Modification Recommended Service Note

P5000A Keysight Streamline USB Vector Network Analyzer

Potential lifted front panel overlay

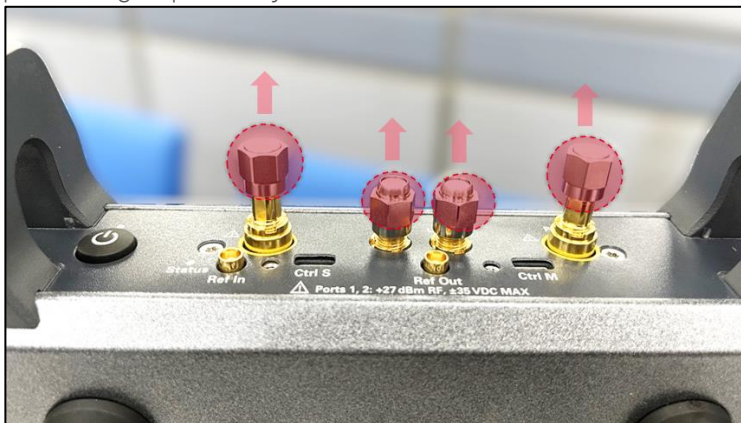
Keysight streamline series vector network analyzer (VNA) of serial number range identified in service note cover page might potentially exhibit the following lifted front panel overlay symptom.

Apart from cosmetic imperfections, the lifted front overlay could have led to non-fully attached *Ctrl S* micro-HDMI cable connector in multi-VNAs setup configuration.

-> Apply this service note only if end users' VNA is exhibiting the following symptom.

Procedure to replace the front panel overlay.

1. Remove the front handles. Detach the 50-ohm termination (LO-In, LO-Out, Port 1 & Port 2) or protecting caps if they are attached to the VNA.

2. Pry open the existing front panel overlay and remove it from front panel.
3. Clean the metal surface thoroughly and ensure it is free of adhesive residue.
4. Affix the new self-adhesive front panel overlay onto the metal surface.
5. Reinstall (reuse) the 50-ohm terminations and port protecting caps accordingly.

6. Reinstall (reuse) the front handles.
